PLAYHOUSE PLAZA

680 East Colorado Boulevard
Pasadena, California

Gensler

April 26, 2010

CORNER TOWER

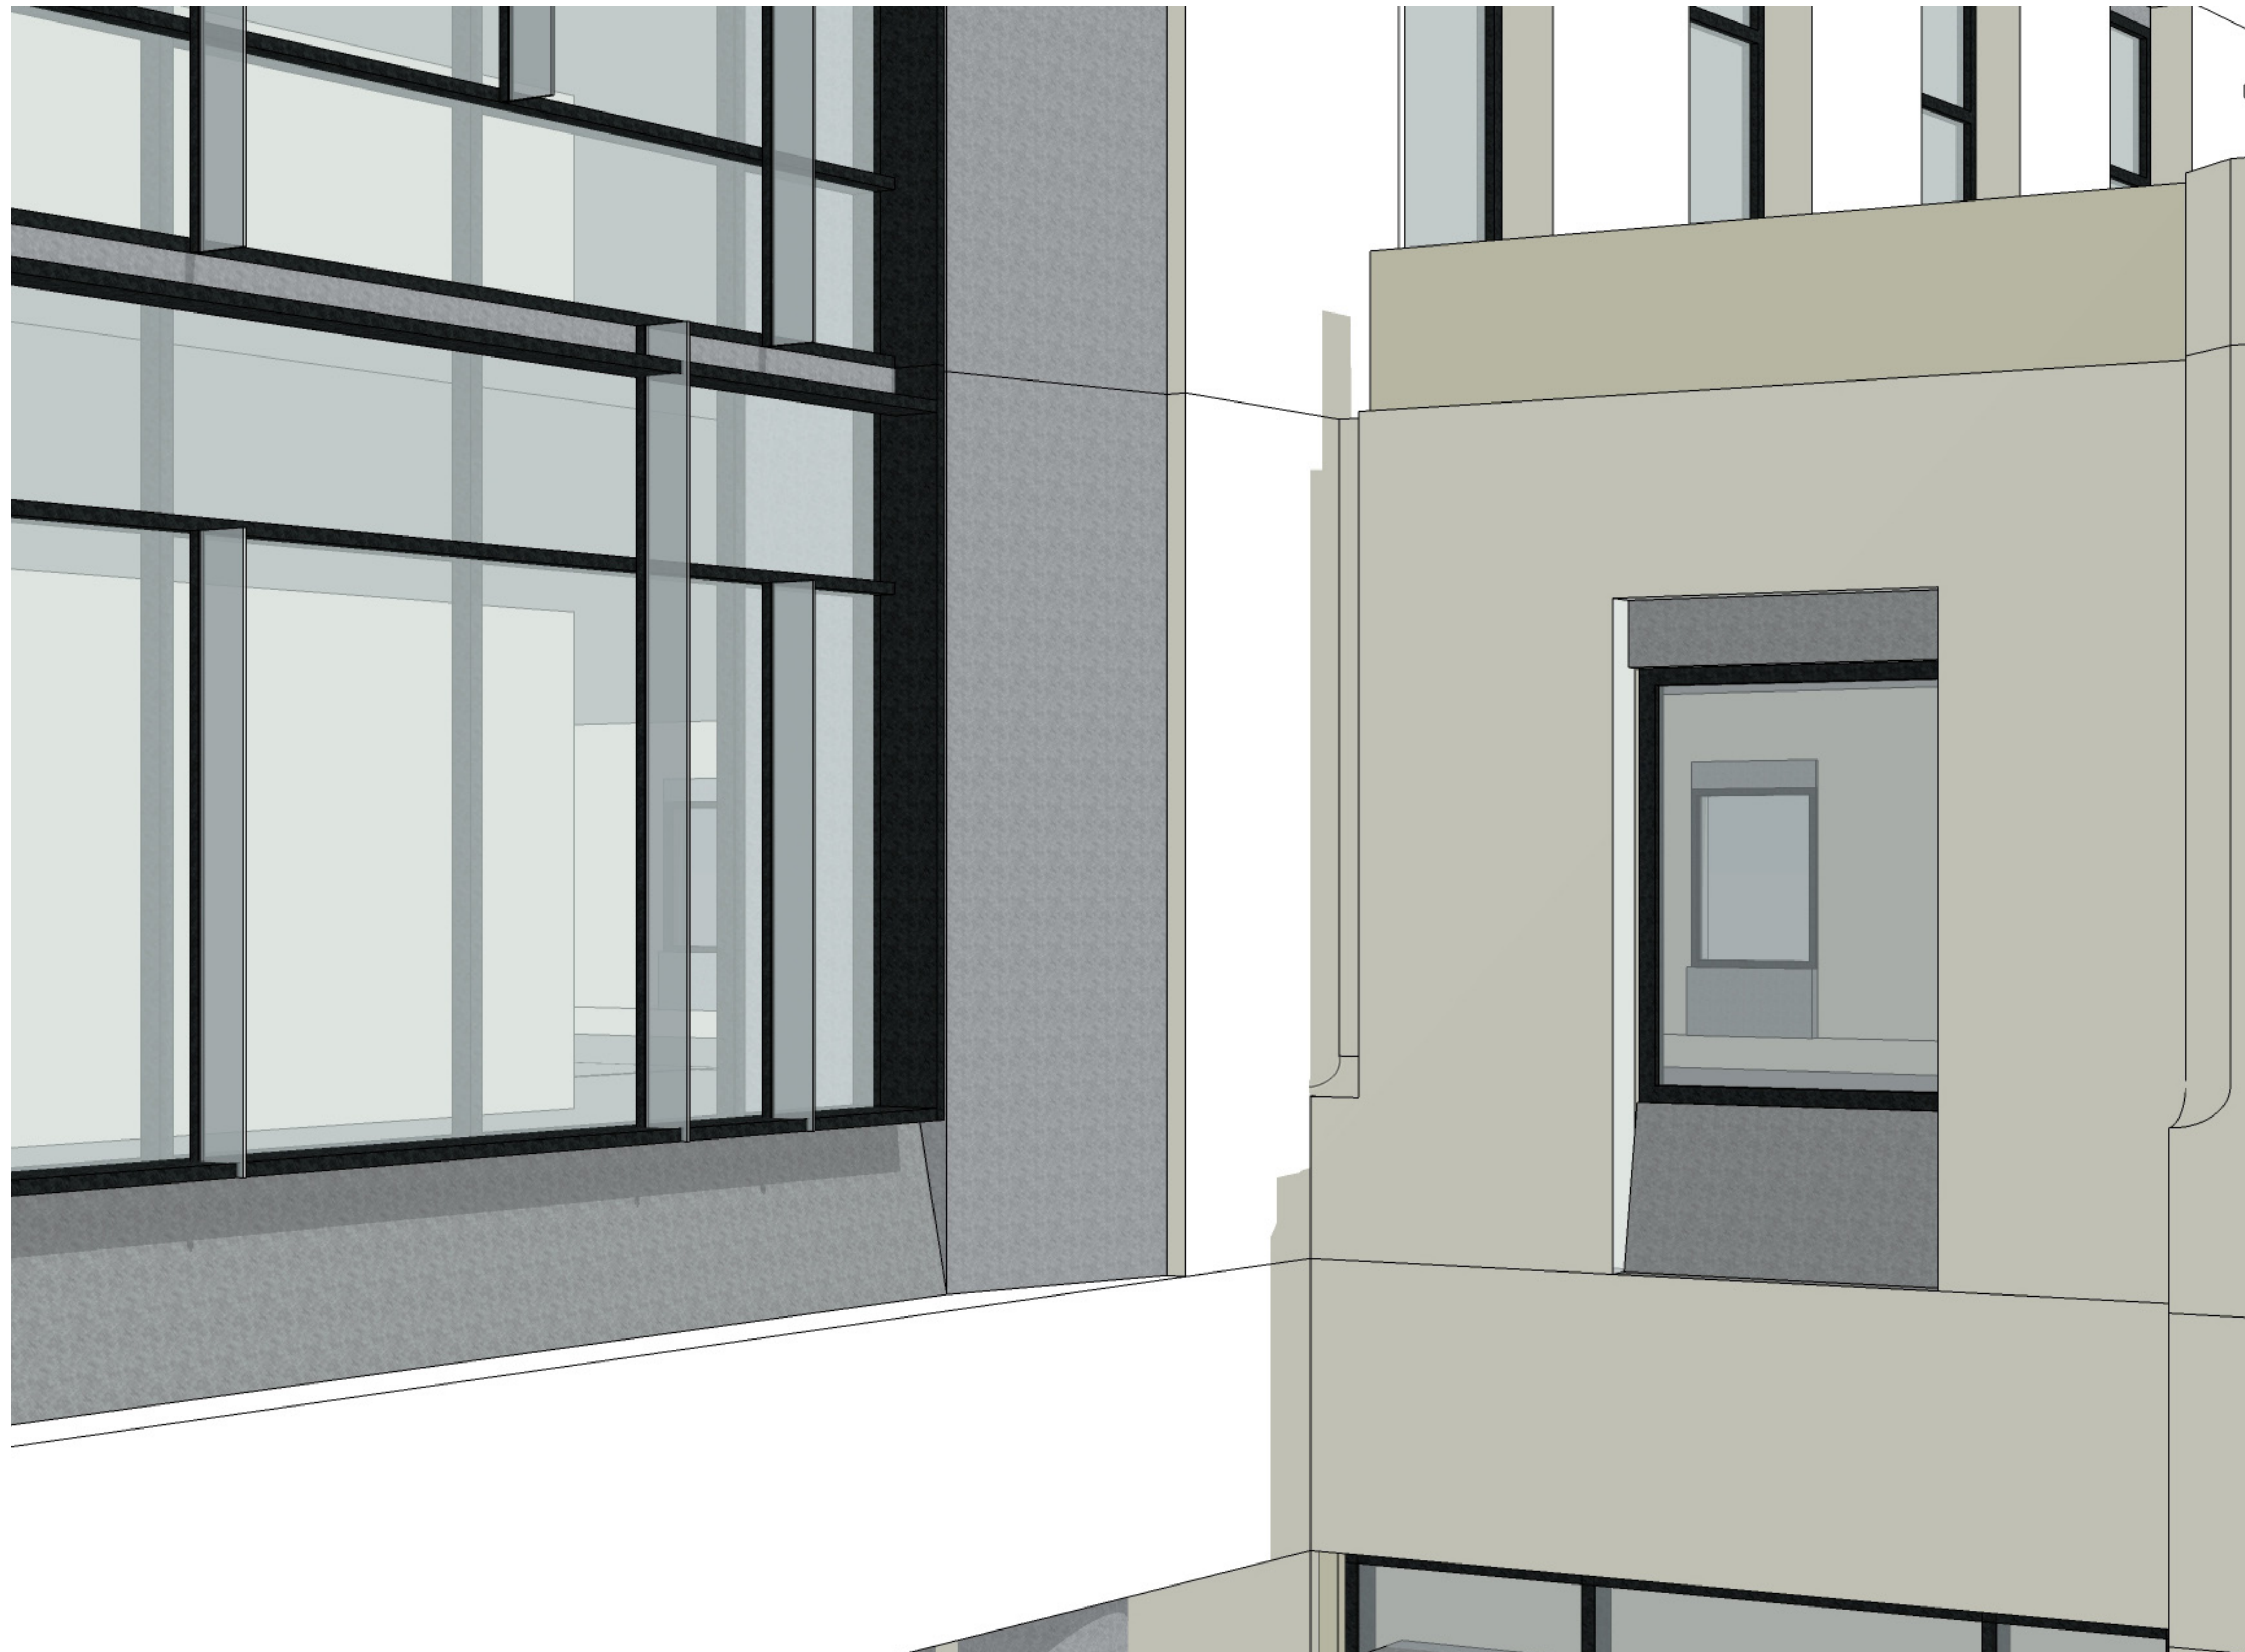
Restudy the connection of the tower on Colorado and the adjoining taller mass of the 5-story building module on El Molino to insure there is a unique architectural response to the intersection of these two different volumes.

ITEM #3f

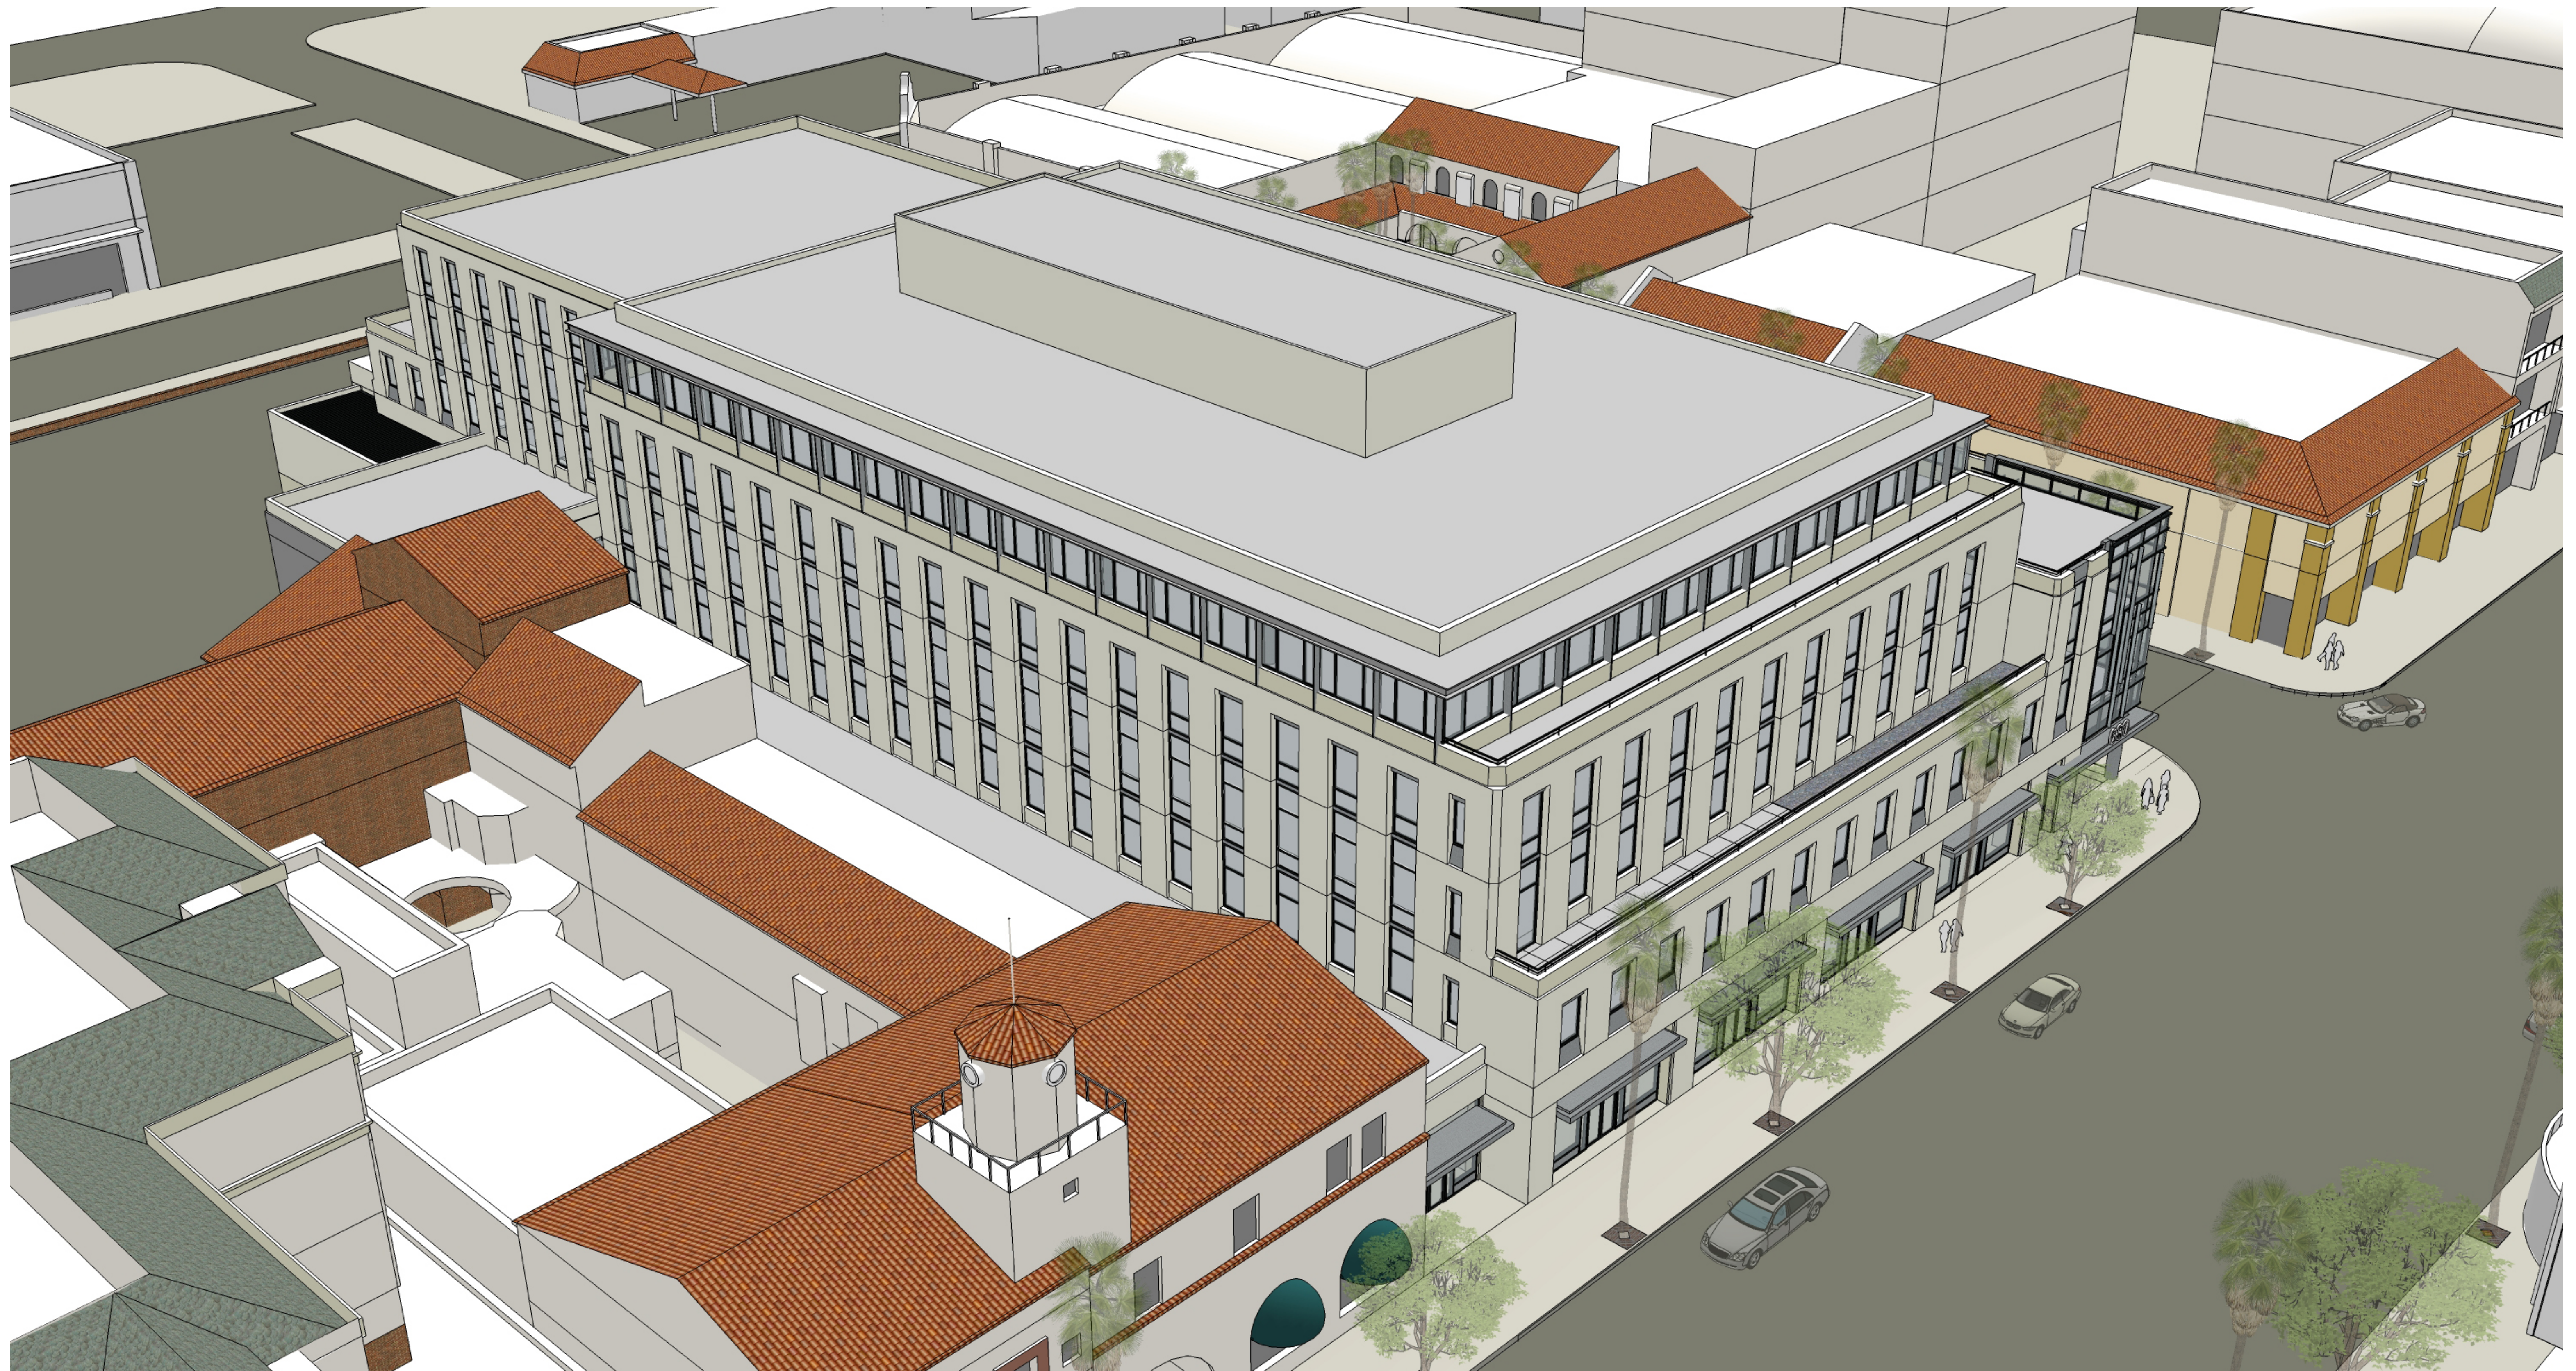
Continue study for possible shifts in materiality to visually break-down the mass of the building and refine of the overall design premise. Materiality studies should include retail bulkheads and base course materiality as well as spandrel elements within the glazing system for the structure.

- The primary surface of the new building will incorporate pre-cast architectural concrete panels or similar GFRC (Glass Fiber Reinforced Concrete) panels. The panels will be of a natural concrete finish, with a light warm grey integral color.
- To comply with current energy codes, the glazing will be high performance IG (insulated glass) units, allowing for high level of transparency and lower reflectivity. Gray substrate will be used to neutrally accent the building.
- All office glazing and storefronts will incorporate extruded aluminum frames with high performance coatings.
- All architectural roof elements, trellises and retail canopies will be constructed of high quality architectural zinc coated metal panels.
- At the ground floor base, dimensional stone wainscots and accents will be utilized to enhance the quality and durability of the pedestrian experience.
